02 September 2021

Reference No. 21490346\_7407-002-LR-Rev1

**NINE MILE SAND MINING GEOTECHNICAL ADVICE TO SUPPORT RESOURCE CONSENT**

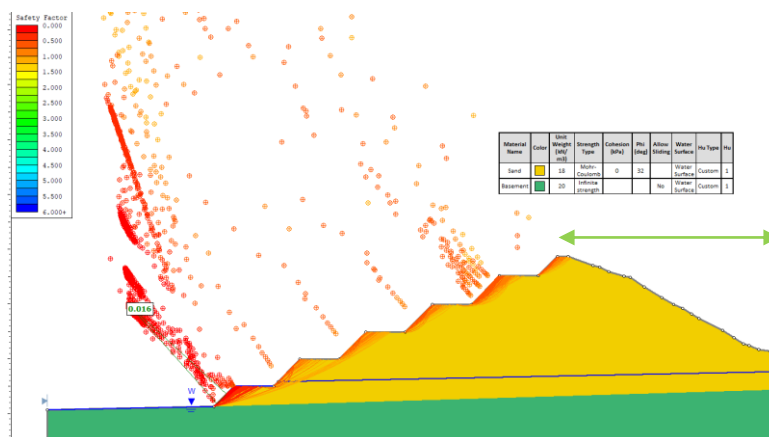
The overall design of the pit slope is stated in the Resource Consent application as being 27°. This is expected to be a conservative (i.e., stable) geometry from a global, large-scale slope stability perspective, even when the water table is intercepted in the pit base. It is difficult to conceive of a failure of such proportions that would substantially intercept the designated environmental buffers. This conclusion applies even to the conservative sand internal friction angle of 32°. The overall pit slope design is likely to have a considerable factor of safety. A computer simulation of the proposed pit configuration using Slide2 software (by RocScience) is shown in Figure 3 to demonstrate the likely small-scale nature of expected instability.

If our geotechnical assumptions of Ferry Dune sand are accurate, a larger scale failure that would substantially encroach into the buffer of the two environmentally important wetlands and/or Blind River is not considered credible over the short-term duration of mining activity. The proposed buffer width to protect the two wetlands, Blind River and indigenous vegetation (i.e., native bush) along the mine boundary is therefore judged to be adequate.

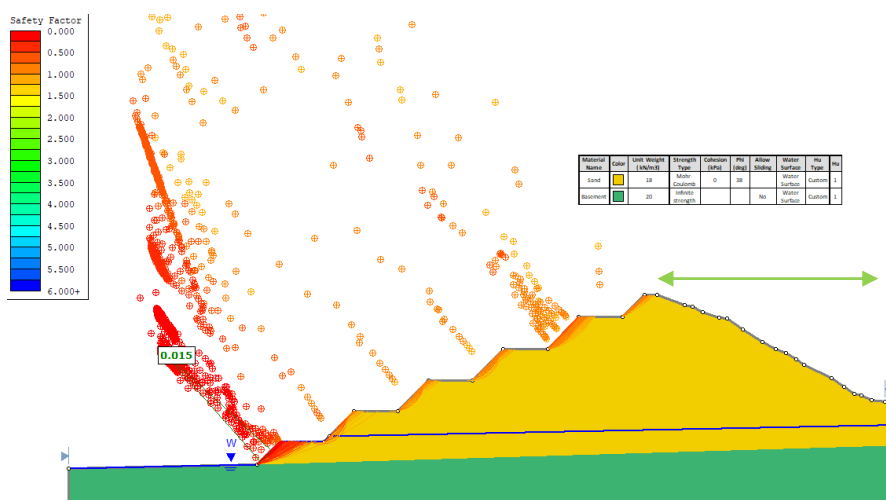
For point 2) we consider that individual benches could potentially fail during mining operation at assumed sand internal friction angle of 38°, as shown in Figure 3. It is likely that failure would involve relaxation and gradual subsidence of a bench in a localised area, rather than rapid failure. This type of failure is particularly expected for the benches within 10 m vertically of excavations below the water table, where the shear strength is reduced due to higher porewater pressures. Cut slope angles could be reduced to the estimated internal friction angle of 38° to mitigate against individual bench failure. A cut slope steeper than 38° may be justified, depending on the actual characteristics of the Ferry Dune sand (see following section).

To manage the risk of slope failure within the active pit WMSC may consider observing the performance of initially formed excavated slopes to guide the geometry of ongoing excavations. A trial bench may be cut at angles between 36° to 45° and incidents of instability observed. A stable cut slope angle may be adopted on this basis, provided the ground conditions are similar throughout the mine. It is recommended that the trial be undertaken at depths greater than 2 m below the present ground surface and be away from environmentally sensitive areas.

- Make overall pit slopes flatter
- Reduce bench height to less than 5 m
- Reduce duration that slope is unsupported

Figure 2: Cross-sections

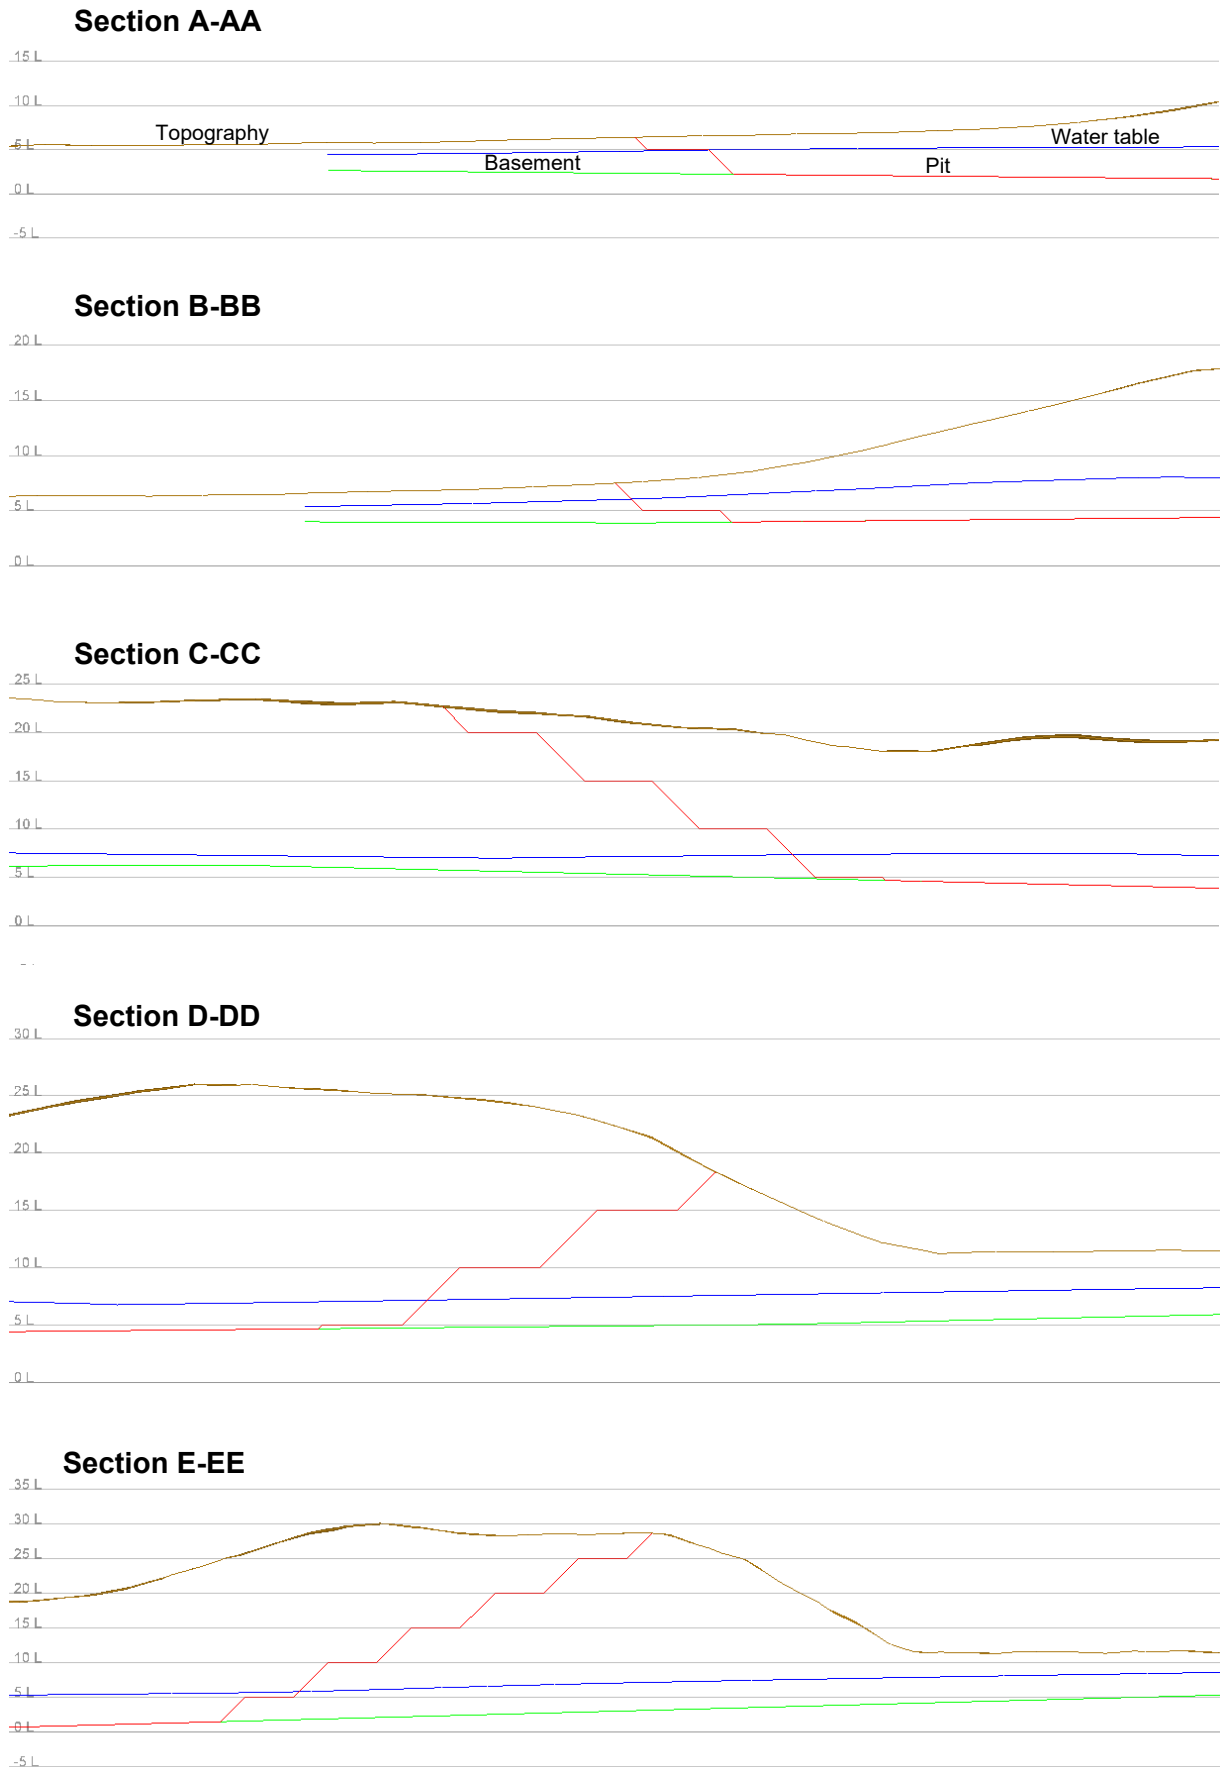
For our assessment of pit slope stability, we have considered the profile E-EE presented in the Mine Planning & Design Services Ltd technical memorandum (17 August 2021), which has multiple benches that are 5 m-high, separated by 7 m-wide horizontal benches. There are two questions to be addressed for the Resource Consent application:
